Subject: Statewide Pavement Preservation Project
MAIN AVENUE - CHOTEAU
STPP 3-2(54)40
CN 5952000

The MDT Environmental Services Bureau has reviewed the Preliminary Field Review/Scope of Work Report (PFR/SOW) for the subject project. Based on the completed Environmental Checklist for Pavement Preservation Projects (Checklist), we have determined that the Statewide Programmatic Categorical Exclusion for these types of projects would cover this project. For your information, I have attached a copy of the PFR/SOW (including the location map) and the Checklist.

Preliminary Field Review Report/Scope of Work

Subject: STPP 3-2(54)40
Main Avenue - Choteau
UPN 5952000
Location Hydraulic Study Report

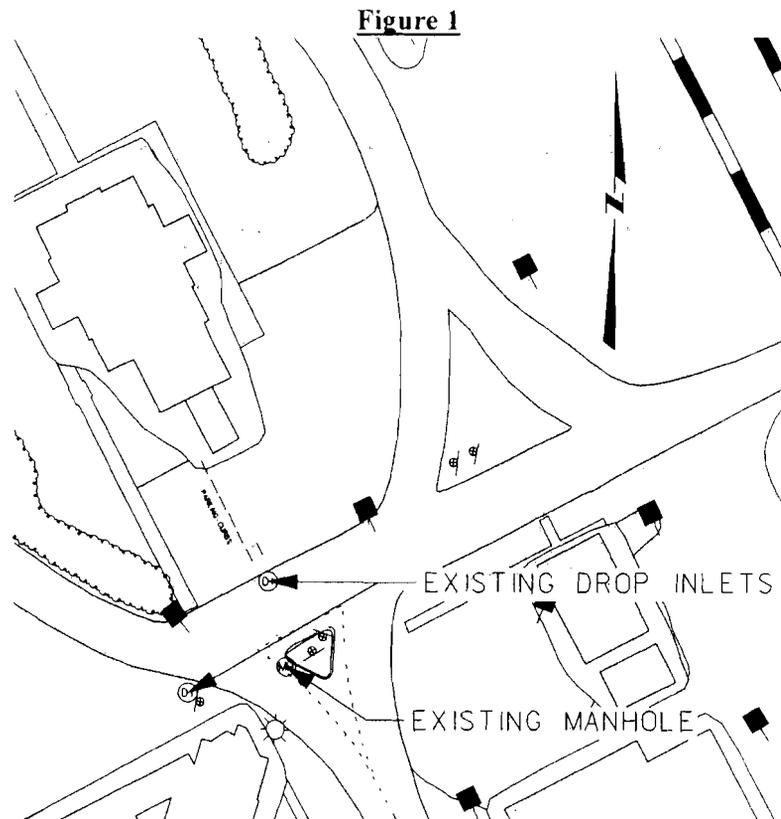
Existing sidewalk ramps within the curb section include small steel pipe drains to allow curb and gutter

flow to pass beneath the sidewalk ramps. Most of the drains observed at the PFR were filled in, clogged with debris, or there was insufficient grade to provide for proper drainage. MDT Maintenance personnel and Kelly Hirsch, City of Choteau Public Works Superintendent, noted that there are a number of ponding problems within the curb section in the vicinity of the sidewalk ramps. At the PFR, it appeared ponding problems were occurring primarily northwest (upstream) of the sidewalk ramps along Main Avenue due to the problems associated with the steel pipe drains beneath the sidewalk ramps.

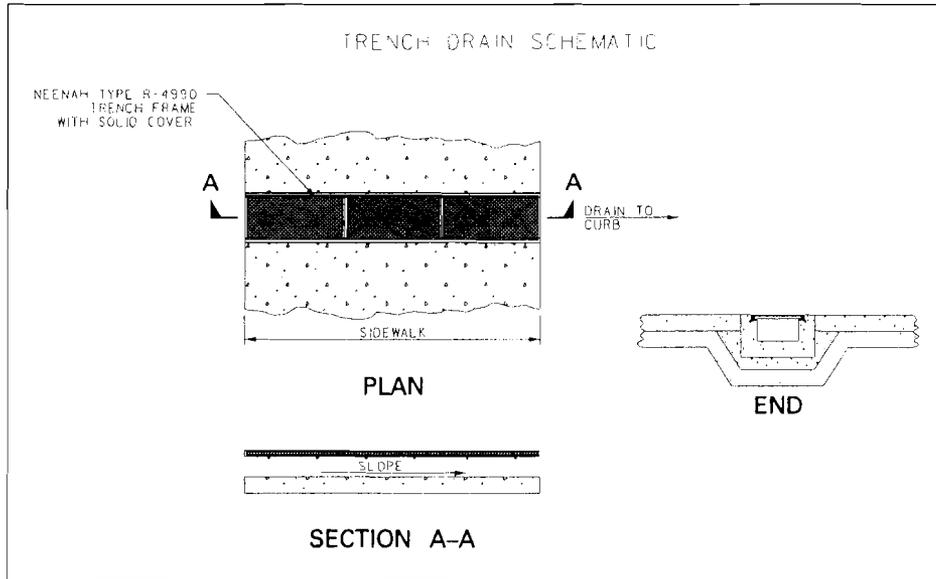
It may be possible to utilize trench drains at the curb ramps to alleviate drainage and maintenance

problems along Main Avenue and meet ADA requirements. After the survey is complete, each intersection within the curbed section will need to be reviewed to determine locations where trench drains may be feasible to promote positive drainage from Main Avenue along the side streets. According to the MDT average bid prices, the unit price for trench drains is \$508/ft. Using a 5-foot sidewalk ramp width the cost per trench drain would be \$2,540. The cost/benefit of installing trench drains will also need to be considered. The following is a schematic for a trench drain.

P-3 & P-9

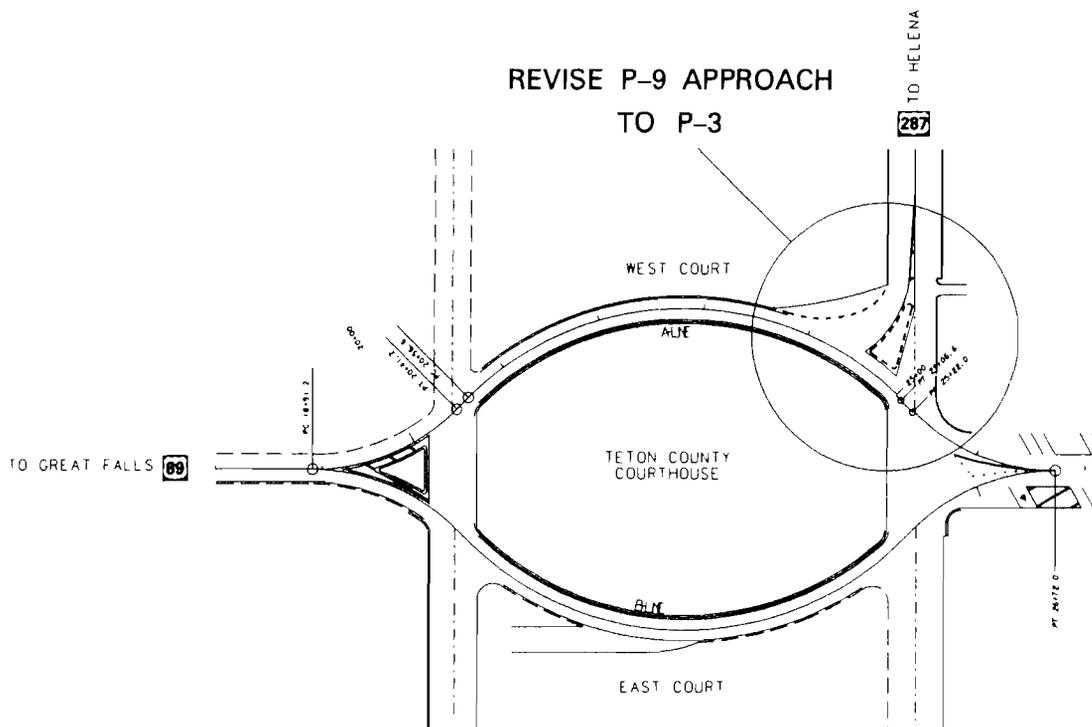
- Revise the existing island to a medial separator so as to eliminate left turn movements from P-9. The existing flush channelizing island appears to have a compacted gravel surface only. Plans have been provided to show the approximate amount of plant mix material to be placed in order to obliterate the existing channelizing island. Thickness of plant mix used in the estimation is the same (0.15-feet) as the overlay thickness for the Main Street project F3-2 (17) 41 completed 1990.

- Traffic control should be a stop sign for P-9 traffic as per Condition A & B of Section 2B.05 of the MUTCD-2003 Edition.
- Insure that signing is revised to direct the one-way traffic to the appropriate destination within the loop. In particular new guidance signing will be needed for Glacier Park bound traffic entering from P-9. Existing guidance signing directing traffic to Great Falls by way of a right turn and to Glacier Park by way of a left turn will be relocated to the south end of the traffic loop to direct Glacier Park traffic to continue on the loop in order to proceed northbound.

- Additional RIGHT ONLY sign will be needed at the P-9 approach.
